TO: Mayor Eric Dial, Town of Tyrone
ATTN TO: Phillip Trocquet, Town Planner, Town of Tyrone
FROM: Mike Alexander, Director, ARC Center for Livable Communities
RE: Development of Regional Impact (DRI) Review

Name of Proposal: Highway 74 Business Tech Park DRI 3628

Description: A DRI review of a proposal to construct 733,882 SF of warehouse distribution facility space in five buildings on a 61 acre site off of SR 74/Joel Cowan Parkway at Jenkins Road in the Town of Tyrone in Fayette County.

DRI

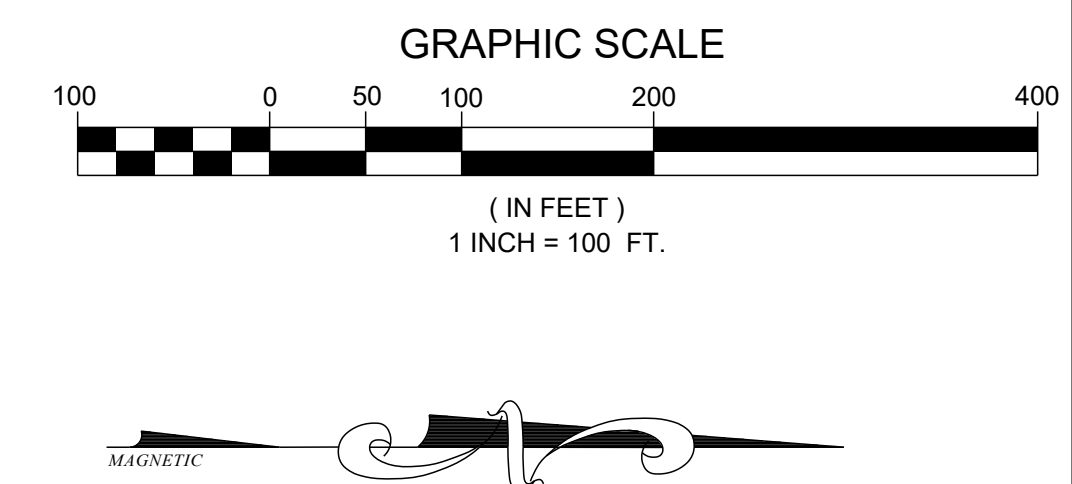
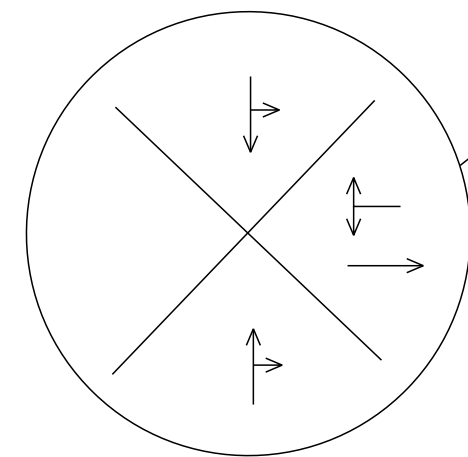
It appears that the headwaters of a mapped stream are located in the area of the southern stormwater pond; the actual location of the stream will need to be identified to definitively determine if any stream buffer requirements apply on this site.

No sidewalks are shown on the site plan, but the TIS states that sidewalks will be provided between buildings. A multi-use trail is proposed on the east side of the project that will connect to Peachtree City; careful alignment of the trail with connecting segments to the north and south will be key to making it viable.

A total of 681 parking spaces are provided; no EV charging stations appear to be proposed. Provision of some EV charging spaces would be supportive of regional EV infrastructure goals.

No sidewalks are shown on the site plan. Sidewalks between buildings connecting to a future external sidewalk system or transit opportunities are considered a minimum component of a multi-modal transportation strategy. The proposed multi-use trail on the east side of the project is a positive feature but it will need to be integrated with connecting segments to the north and south to ensure its viability. Care should be taken to ensure that the constructed development provides an interconnected, functional, clearly marked and comfortable pedestrian experience on all driveways, paths, entrances, and parking areas. To the maximum extent possible, new driveways and intersection corners where pedestrians will

The proposed project site plan shows no blue line streams on the property. The USGS coverage for the project area shows an unnamed tributary to Whitewater Creek ending in a pond at or near the eastern boundary of the property in the approximate area of the larger stormwater pond shown on the site plan. The precise location of the stream will need to be identified to definitively determine if any stream buffer requirements apply on this site. In addition to the Part 5 criteria listed above, the City of Tyrone stream buffer ordinance requires a 50-foot undisturbed buffer and a 75-foot impervious surface setback. Any unmapped streams on the property may also be subject to the City's Stream Buffer Ordinance. Any unmapped streams as well as any other waters of the state on this property are also subject to the State 25-foot Sediment and Erosion Control Buffer.

If trucks enter to the site using Jenkins Road via Driveway C, then the truck will have to pass through the employee parking to reach the service courts.

DRI #3628	
HIGHWAY 74 BUSINESS	
TECH PARK	
SCALE:	1"= 100'
DATE:	05/24/2022
DRAWN BY:	FEI LI
PROJECT MANAGER:	WESLEY REED P. E.
QA/QC CHECK:

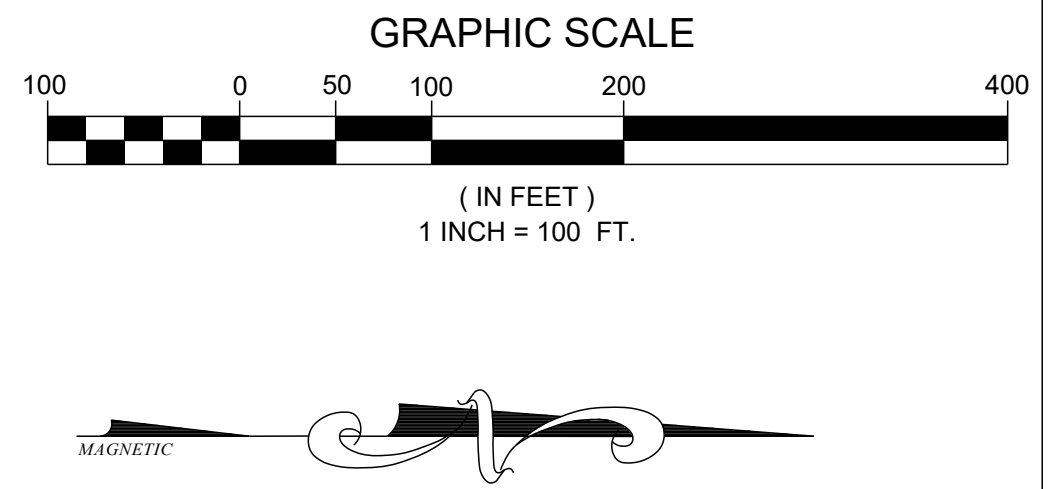
The proposed project site plan shows no blue line streams on the property. The USGS coverage for the project area shows an unnamed tributary to Whitewater Creek ending in a pond at or near the eastern boundary of the property in the approximate area of the larger stormwater pond shown on the site plan. The precise location of the stream will need to be identified to definitively determine if any stream buffer requirements apply on this site. In addition to the Part 5 criteria listed above, the City of Tyrone stream buffer ordinance requires a 50-foot undisturbed buffer and a 75-foot impervious surface setback.
